**RESPONSE TO COMMENTS ON REVISED DRAFT ROD
OPERABLE UNIT 2C, LANDFILL SITES 3 AND 5
FORMER MARINE CORPS AIR STATION EL TORO
EL TORO, CALIFORNIA
CTO-0062, APRIL 2007**

BEI-7526-0062-0184

Comments from Penny Leinwander, CDPH

Record of Decision, OU-2C
Figure 7-2
Conceptual Grading and Monitoring Plan
Site 3 - Original Landfill
 Former MCAS El Toro, California

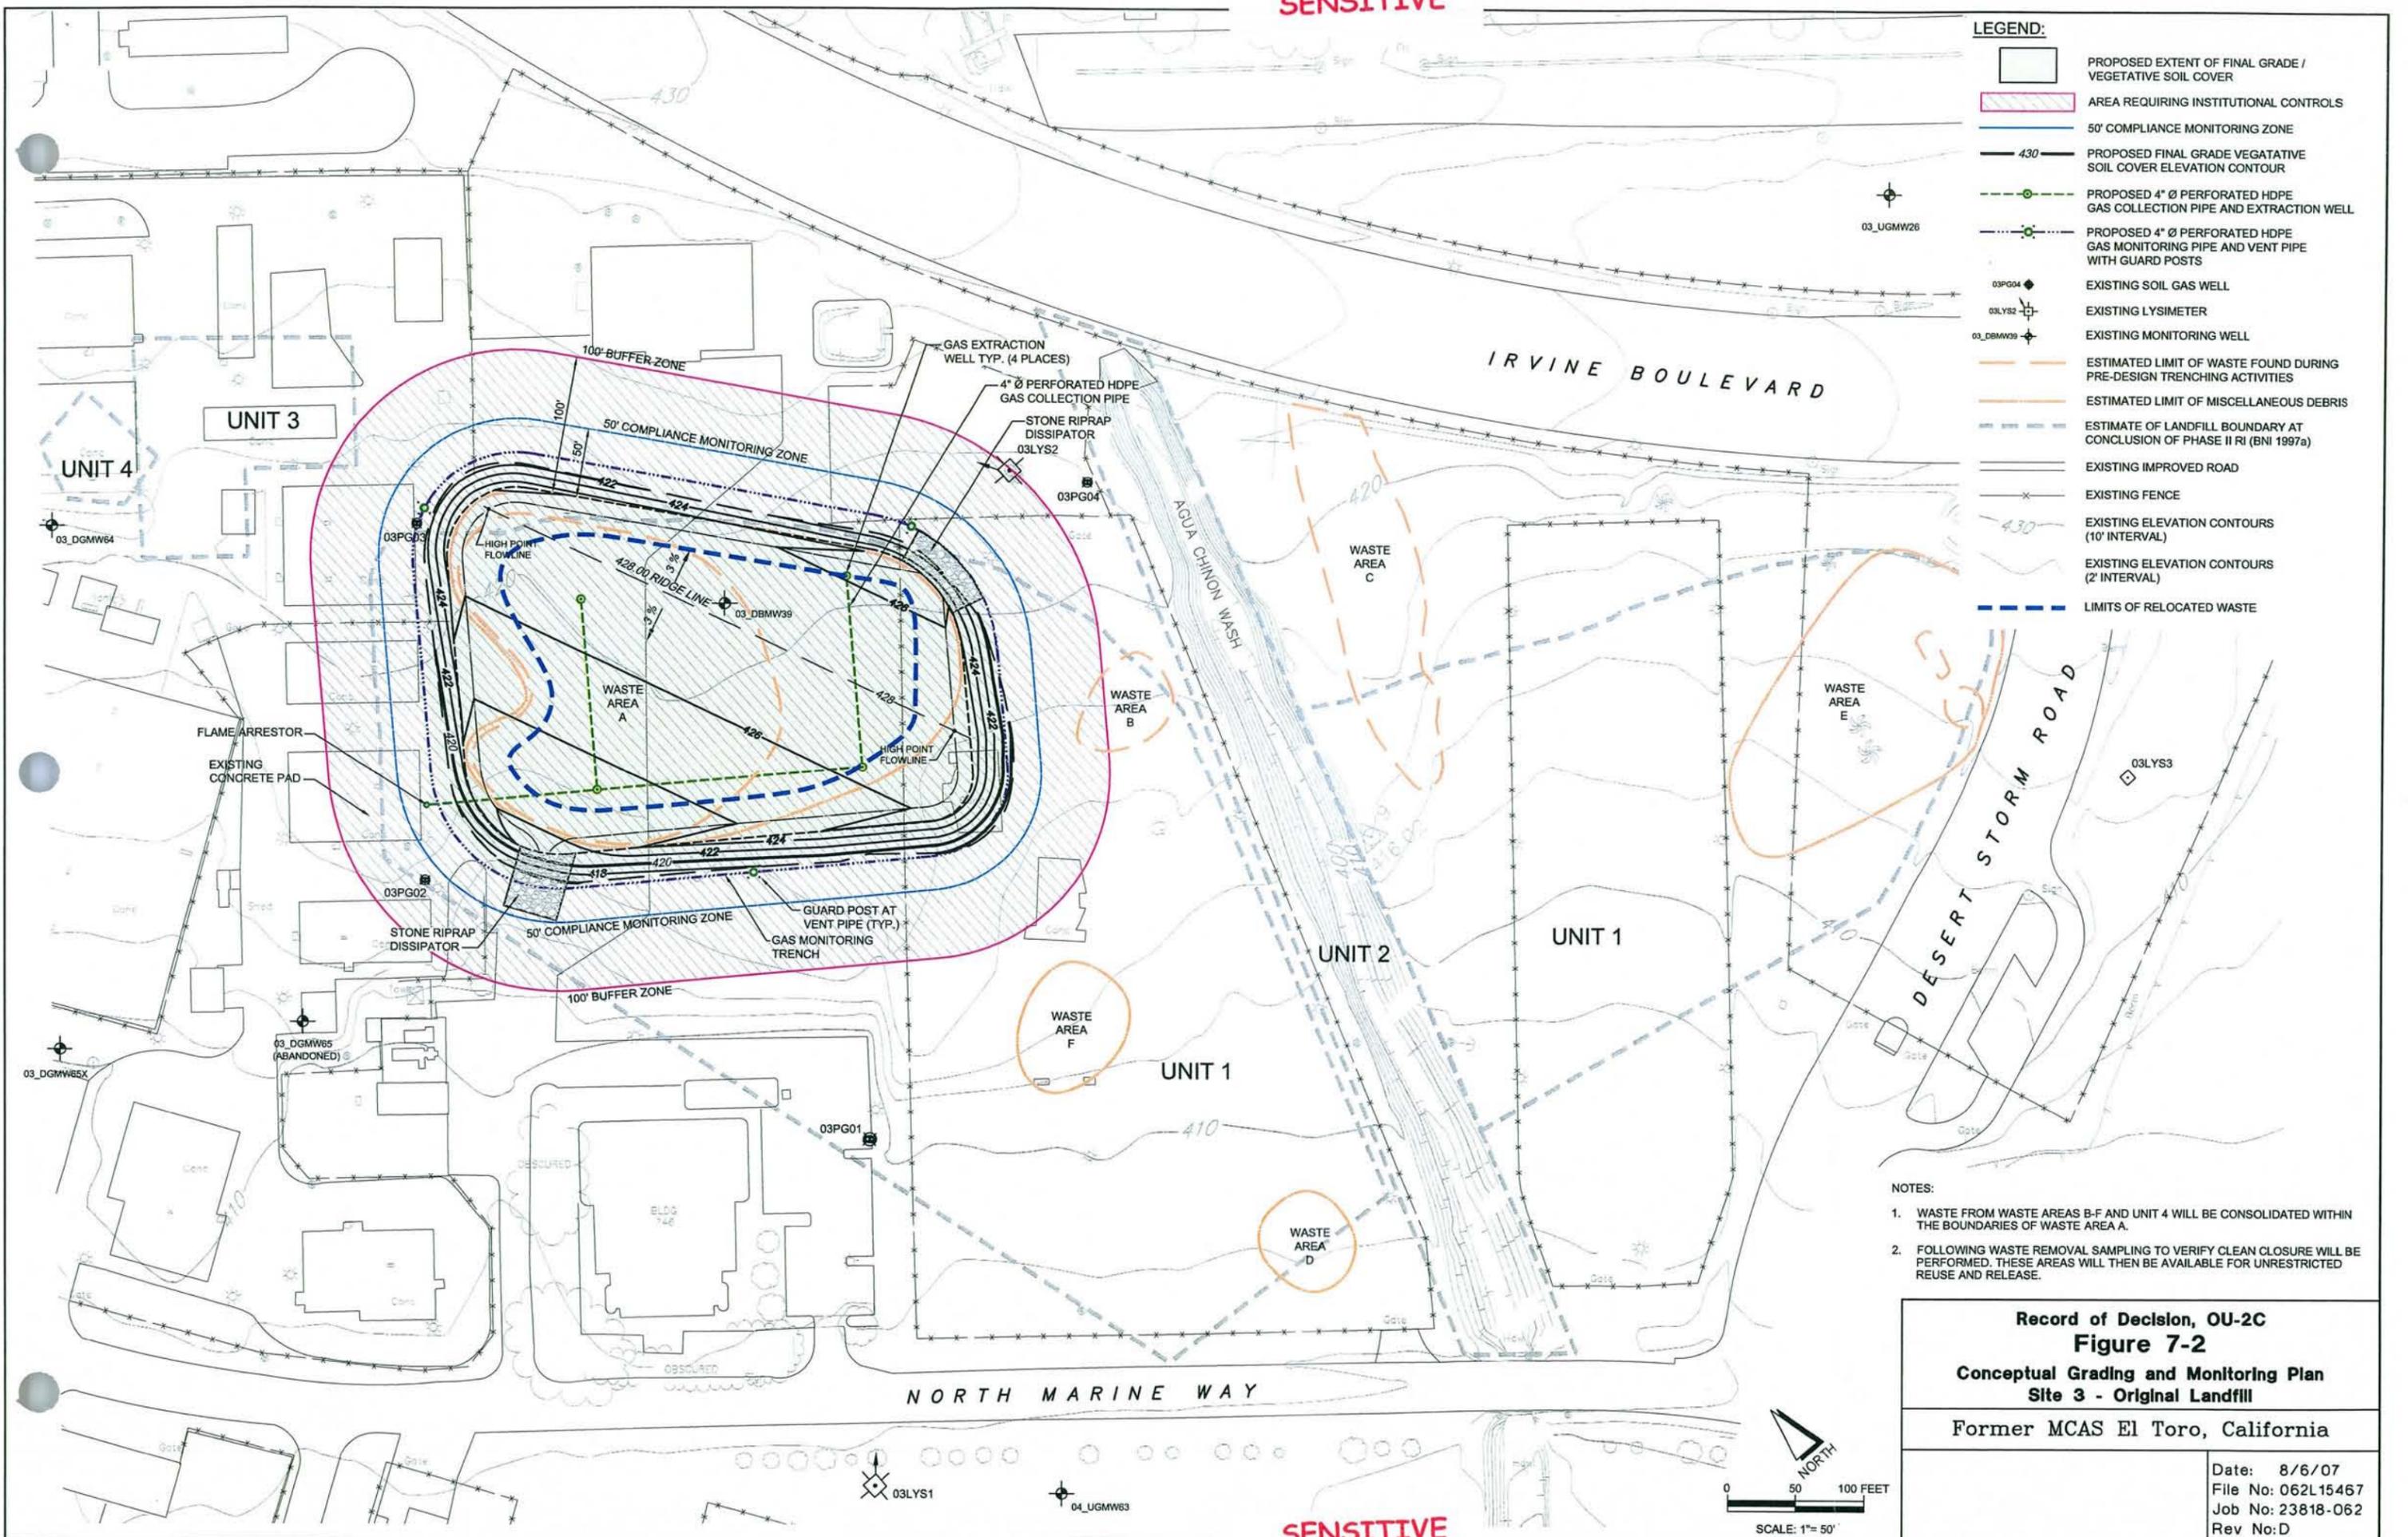
Figure 7-2: The northern portion of the proposed waste cell footprint after reconsolidation of Site 3 waste is located outside of the defined boundary of Site 3. Such an extension of that portion of the proposed waste cell will trigger the federal and State municipal solid waste siting regulatory requirements and all other applicable regulations, including a conforming liner.

Figures 7-2 (Site 3) and 7-3 (Site 5), which are attached to these RTCs for reference, have been revised to show the areas requiring ICs at both sites.

Figure 7-2 depicts waste boundaries at Site 3 that are based on the Phase II RI and the pre-design investigation reports. At the location noted in the comment, the waste boundary established during the pre-design investigation extends beyond the boundary depicted in the Phase II RI Report. Consolidated wastes will not be placed outside the maximum extent of either boundary; therefore, no new waste cell will be constructed and federal and state municipal solid waste siting requirements will not be triggered.

For clarity, Figure 7-2 has been revised to include the anticipated limits of waste consolidation within Waste Area A. This figure and Figure 7-3 (Site 5), have also been revised to illustrate the area requiring institutional controls. Both figures are attached to these RTCs for reference.
